GNRO-2011/00017

SUBJECT: Request for Additional Information Regarding
Extended Power Uprate
Grand Gulf Nuclear Station, Unit 1
Docket No. 50-416
License No. NPF-29

Grand Gulf Nuclear Station, Unit 1 Extended Power Uprate

Response to Request for Additional Information

Figure 1 - Short Term Temperature Response - Main Steam Line Break

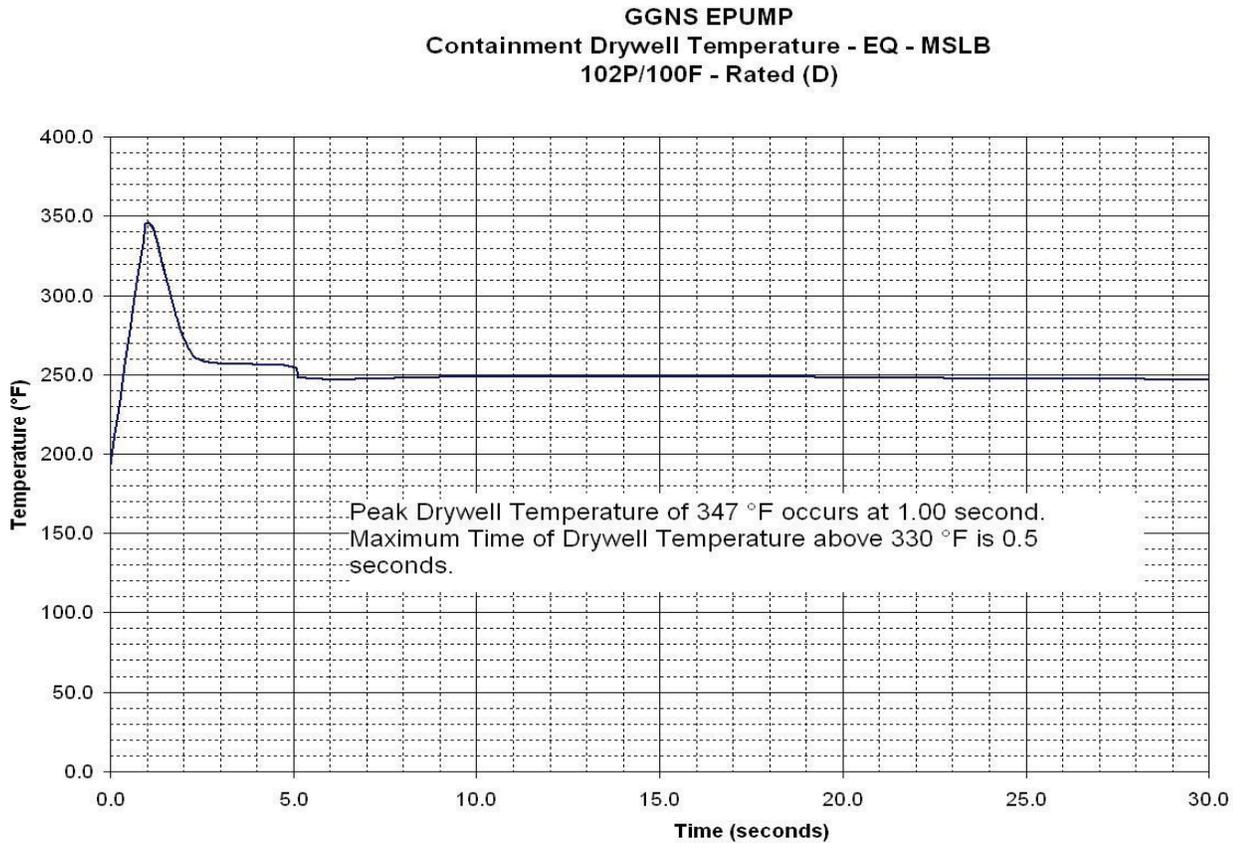
On page 2-10 of attachment 5B of its letter dated September 8, 2010, the licensee states that the qualification level peak temperature for the drywell is 340°F and the peak temperature for the EPU conditions was determined to be <340°F. However, the licensee stated that the EPU peak temperature ignores a short initial one-second transient to 347°F and that this transient would have an insignificant effect on the coating temperatures. Please discuss why the qualification testing remains bounding despite having a containment temperature that exceeds the test temperature profile.

The 347°F is a brief spike (or transient) in drywell temperature that happens within the first second of the accident (see Figure 1 - Short Term Temperature Response Main Steam Line Break), then drops below and stays below the 340°F design temperature. In regards to Environmental Qualification, the focus is on the temperature that the components and materials of interest attain. The protective coatings in containment do not instantaneously heat up to the temperature of the drywell environment; rather, the temperature response of the coatings is based on convective heat transfer properties and thermal capacity. Exposure to a very brief spike (one second) of elevated temperature is not nearly long enough to heat up the protective coatings much beyond their initial temperature condition ($\leq 135^\circ\text{F}$ per GGNS Technical Specifications). Rather, the analysis demonstrating that the drywell temperature remains below 340°F confirms that the ultimate peak temperature of the coatings themselves would remain below this qualification temperature, in conformance to design requirement.

Figure 1: GGNS SFP Map

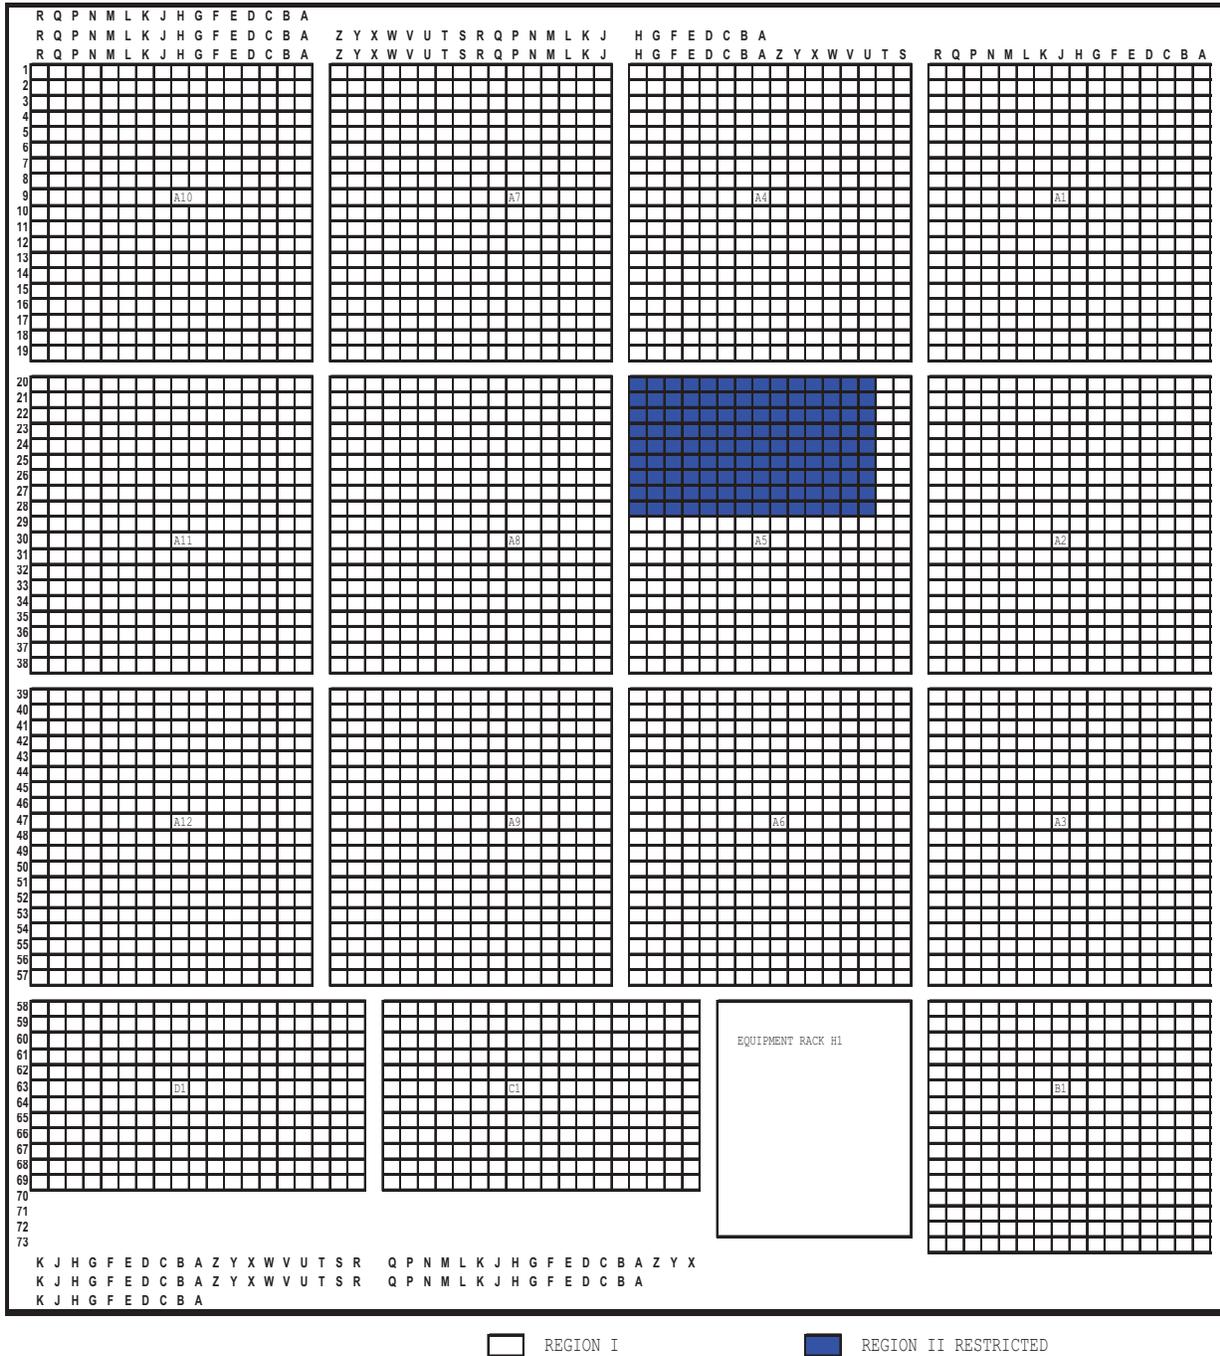
Please discuss the extent to the Region II expansion as it relates to the degradation in the Boraflex panels in the spent fuel pool. In other words, discuss how the new Region II locations are determined and added after each Blackness and BADGER test campaign. Please provide a spent fuel pool map illustrating the current Region I and II locations.

As described in response to RAI # 2, new Region II locations are established based on Racklife calculations. If either the Region I Racklife areal density or dose criteria are not met for a given Boraflex panel, the two fuel storage cells face-adjacent to that panel are classified as Region II storage locations. Region II storage locations are controlled in one of two ways:

- Fuel is restricted from being loaded into applicable cells;
- Once a minimum contiguous area is configured as a Region II area, an acceptable configuration as demonstrated in the CSA is established. Cells that still meet Region I criteria may be conservatively declared as Region II cells in order to establish a minimum contiguous area and implement the Region II storage configuration.

The spent fuel map, illustrating the current region designations of the storage cells, is provided in Figure 1. Note that the current Region II area has not been expanded since its initial creation in 2000.
